**Howard County
Health Department**

RECEIPT DATE: 11-7-24 **ONSITE SEWAGE DISPOSAL SYSTEM** P 587859

PROPERTY ADDRESS: 425 Watersville Road

SUBDIVISION: Romiti Property LOT: Par F TAX ID: 04-370791

425 Waterville Rd.

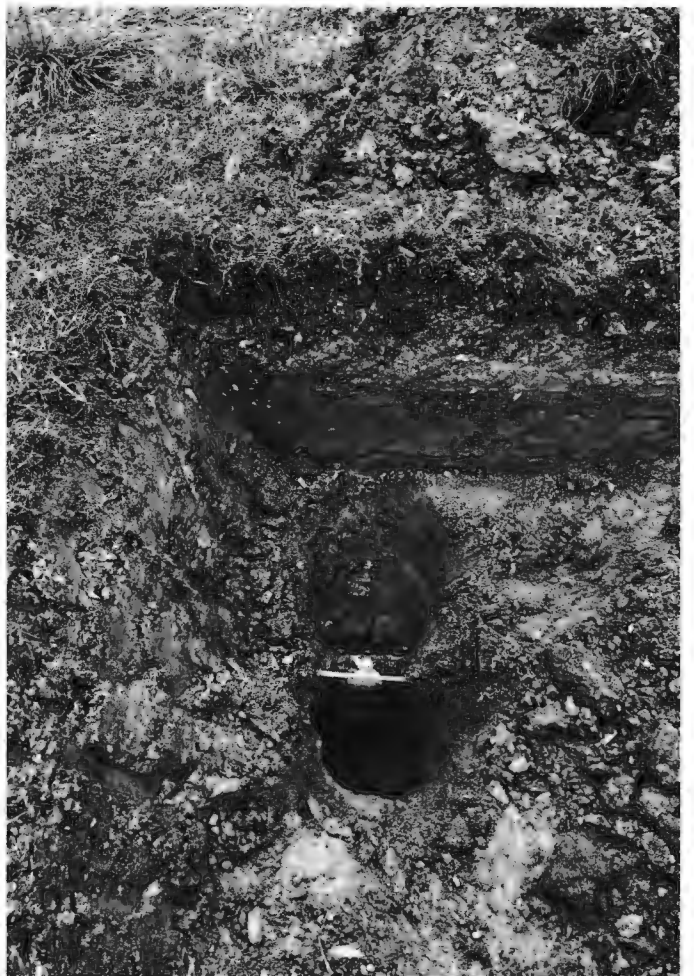
12/19/2024 Well Line at property was installed without the Health Dept.'s approval. Sam's Creek dug 10 holes along the line to verify Well Line depth. Line was 3ft below grade.

Well line was boded and backfilled with clean dirt near house. Contractor says they added about 2' of fill and I verified. From grade to 2.5'/3' down is very rocky. (MB)

SEWAGE DISPOSAL SYSTEM SPECIFICATIONS WORKSHEET

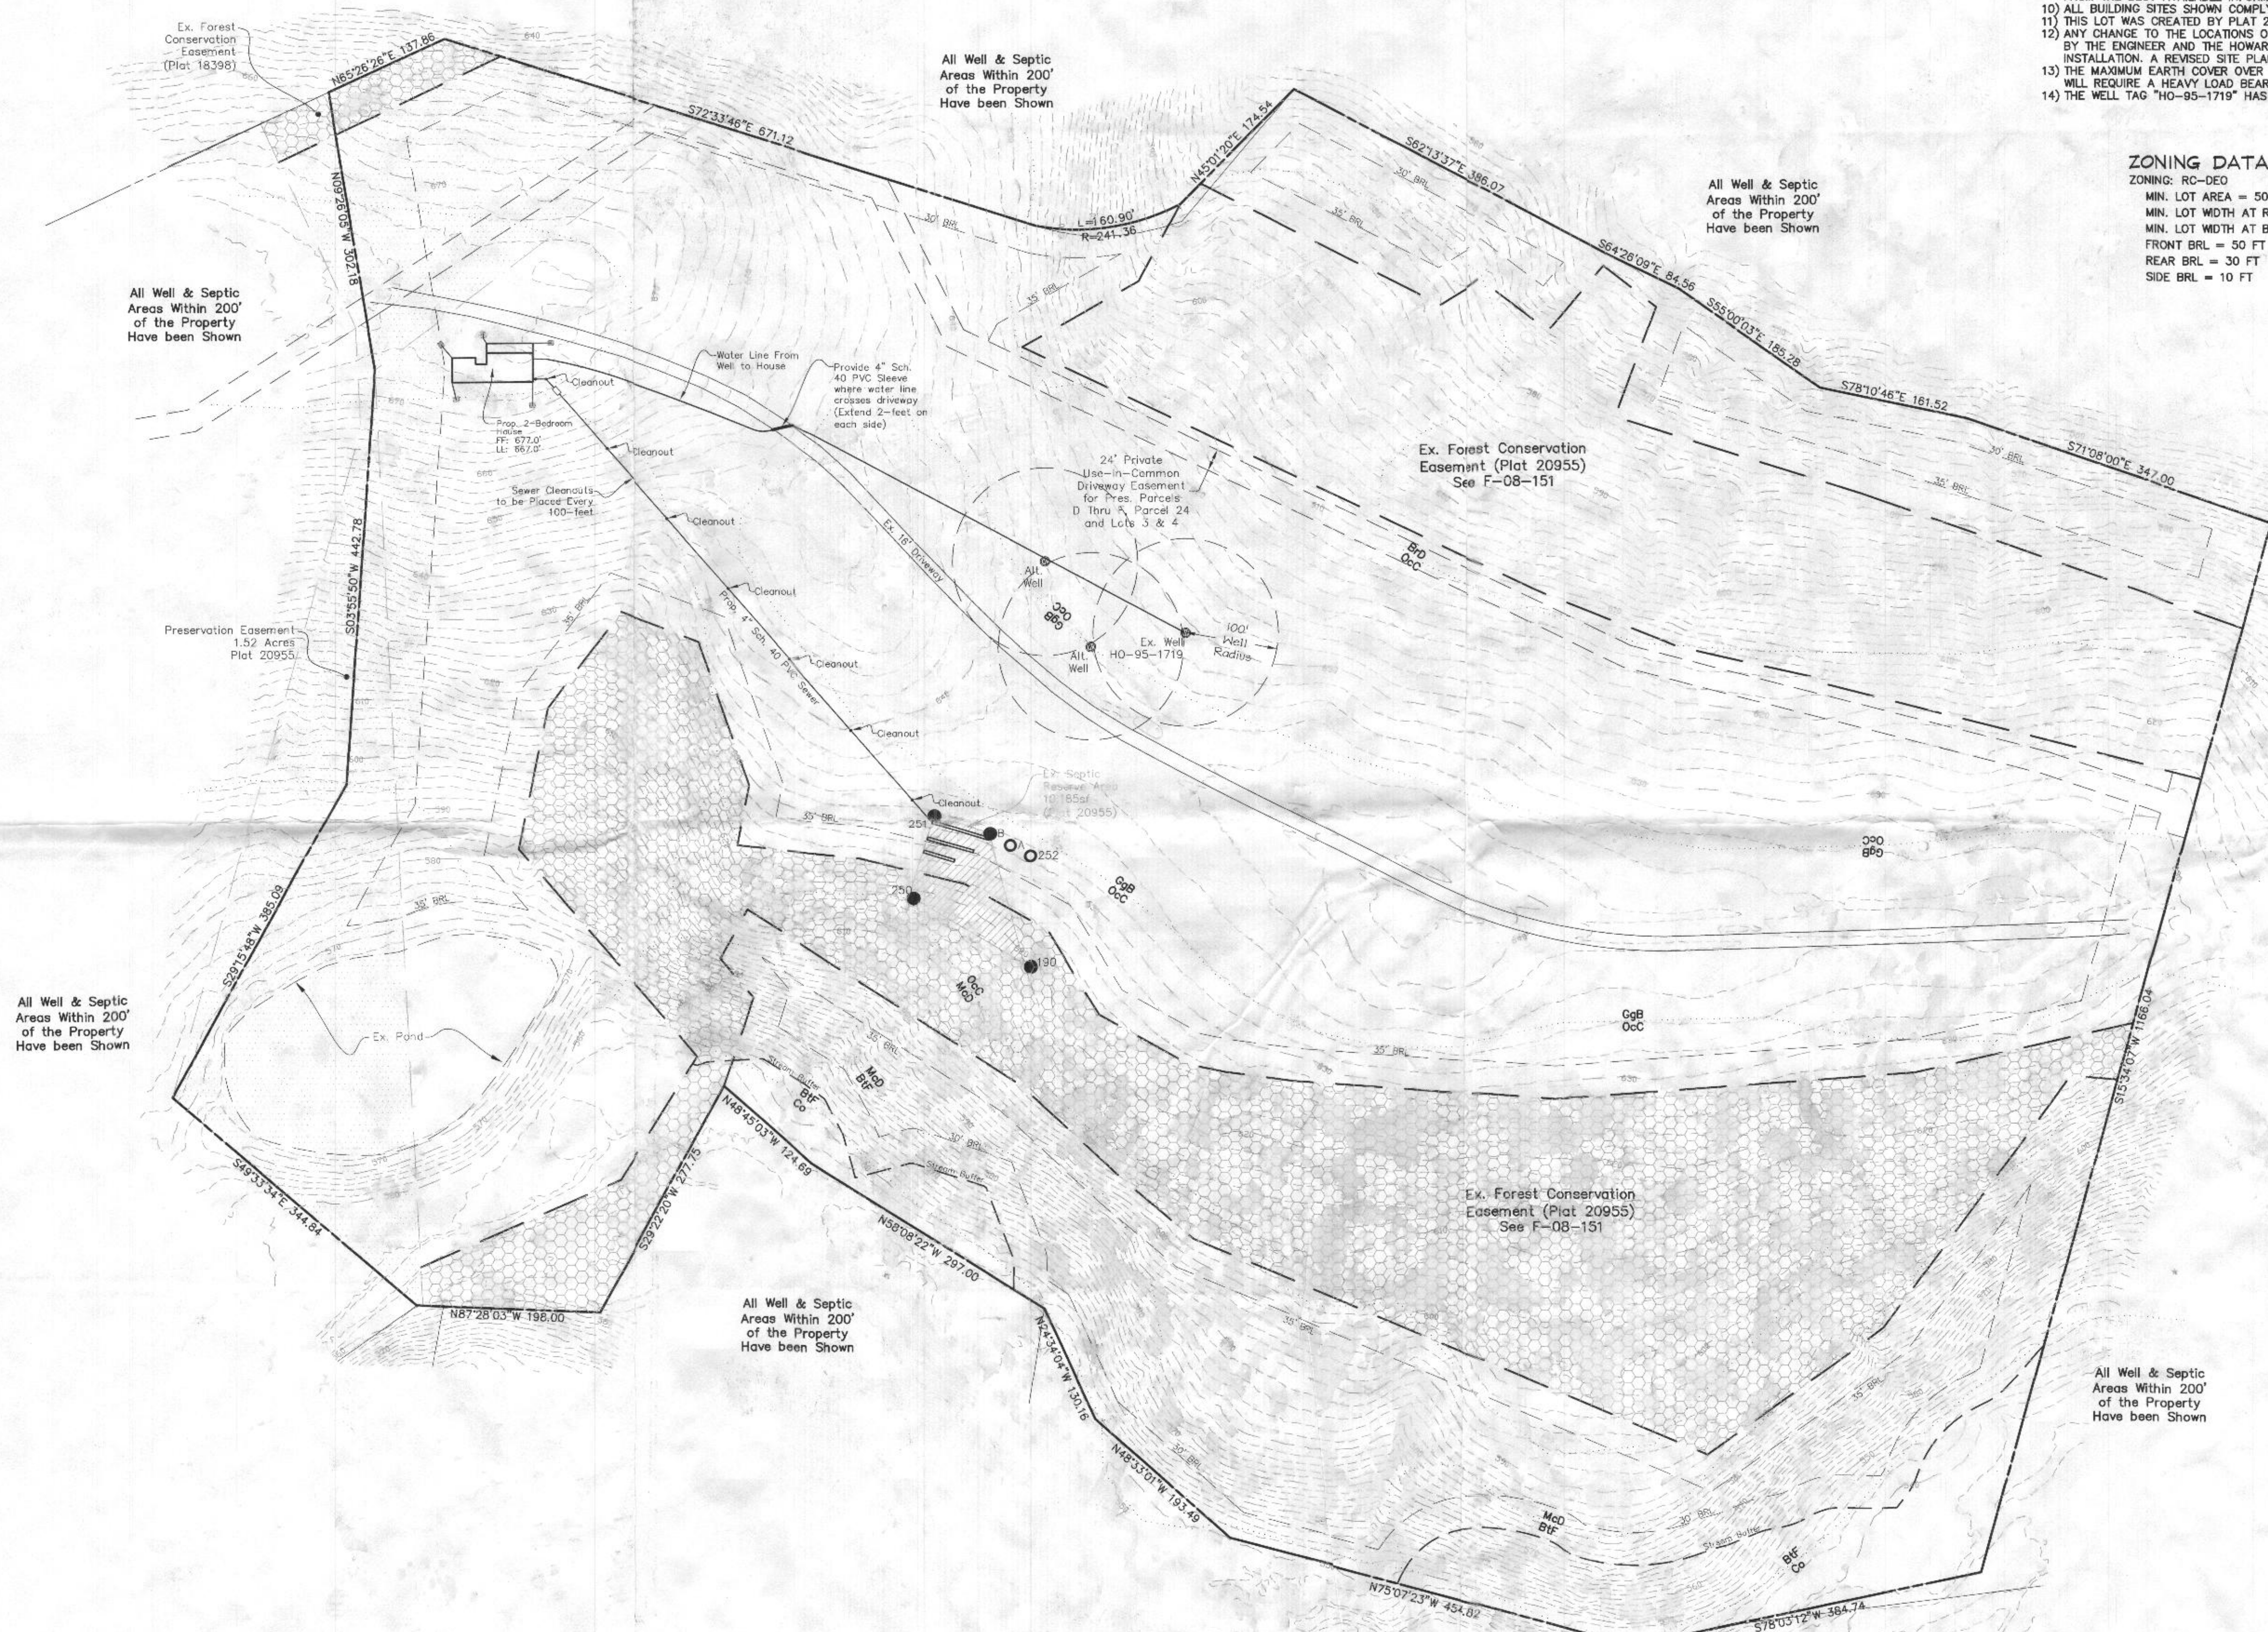
Additional requirements: *Keep Trenches West as possible within SDA.*
